REMARKS

Amendments to the drawings:
Replacement FIG. 15
(mark-up and clean versions)

FIG. 15
MARK-UP

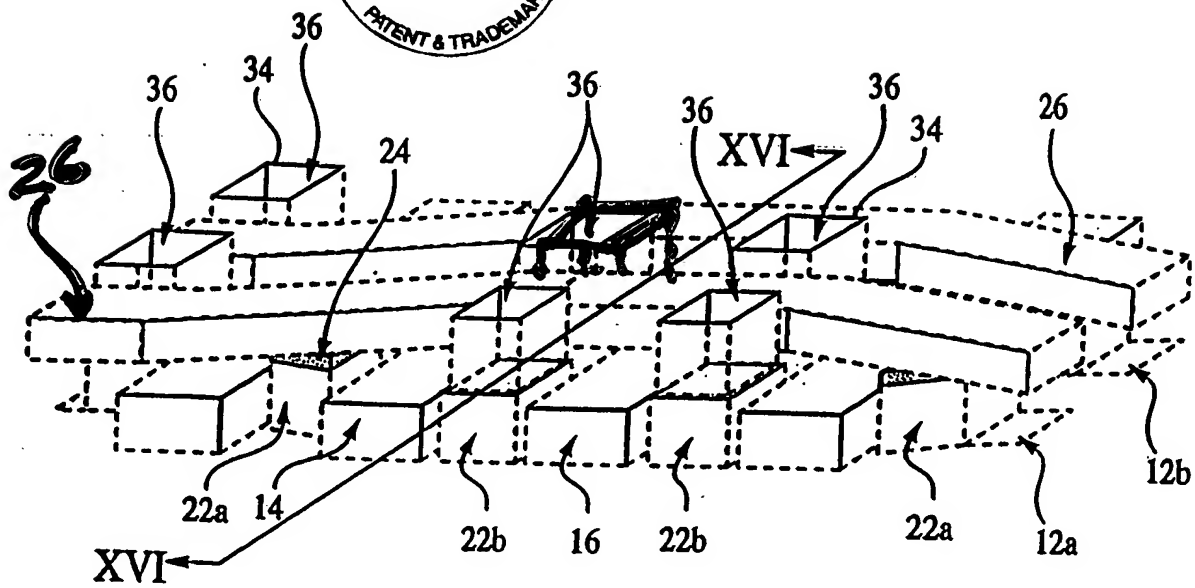
The Office Action indicated that no drawing shows "an interconnect line . . . in electrical contact with said first conductive stud (i.e., claim 1)." This feature of the claim(s) is shown in, for example, FIG. 15 where the first conductive stud (22a) is shown

FIG. 16 is also objected to because it allegedly has a cross-section not corresponding with the line XVI-XVI of FIG. 15. The line XVI does indeed correspond to the drawing of FIG. 16; it passes through the middle of the drawing of FIG. 15. Because of the perspective view shown in FIG. 15, the line does, however, bisect the location of the contact stud (22b) as shown in FIG. 16. It is the same cross-section line as shown in FIG. 1 (i.e., line II-II). The replacement FIG. 15 shifts the position of the contact (36) slightly to make this more clear.

to be in electrical contact with the overlying interconnect line (26) through the cap (24) over the stud (22a) (although the cap is absolutely necessary). Although not believed necessary, Applicant submits a replacement FIG. 15, which adds a reference "26" to more clearly label the interconnect line (26) in electrical connection with contact stud (22a). Mark-up and clean versions of this replacement drawing are attached at Appendix A, with changes shown in red. No new matter is added.

In view of the above and based on the replacement drawing submitted herewith, Applicant respectfully requests that the replacement drawings be entered and the objection to the drawings be withdrawn.

FIG. 16

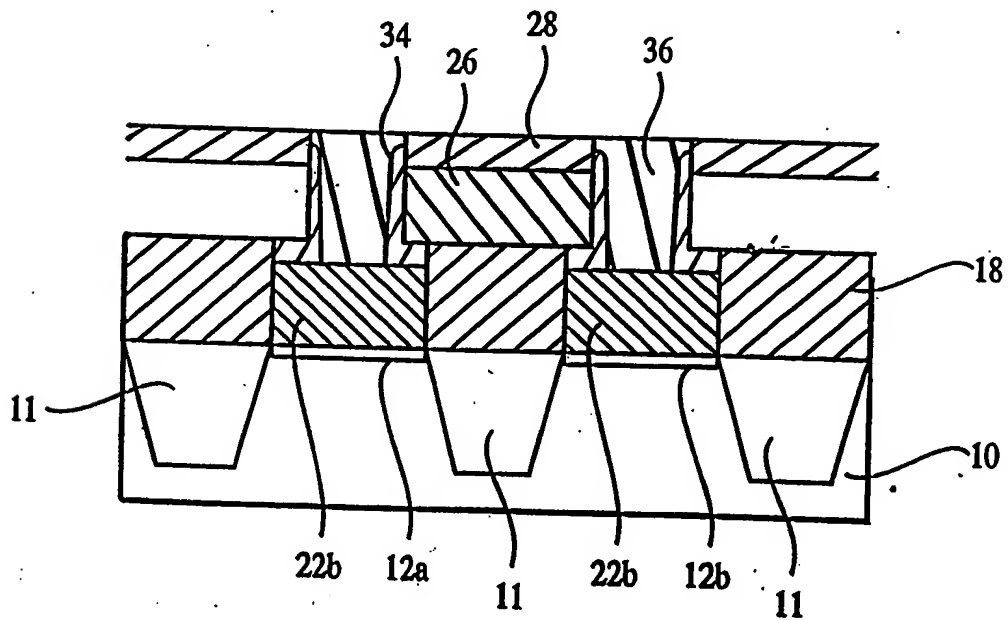
The Office Action also indicates that in FIG. 16, which shows a cross section of the structure of FIG. 15 through line XVI-XVI, the interconnect line (26) is insulated from both conductive studs (22b). This is correct because FIG. 16 shows how some studs (22b) are so insulated from the overlying contact line (26), which is electrically connected to an adjacent contact stud (22a), as shown in FIG. 15.
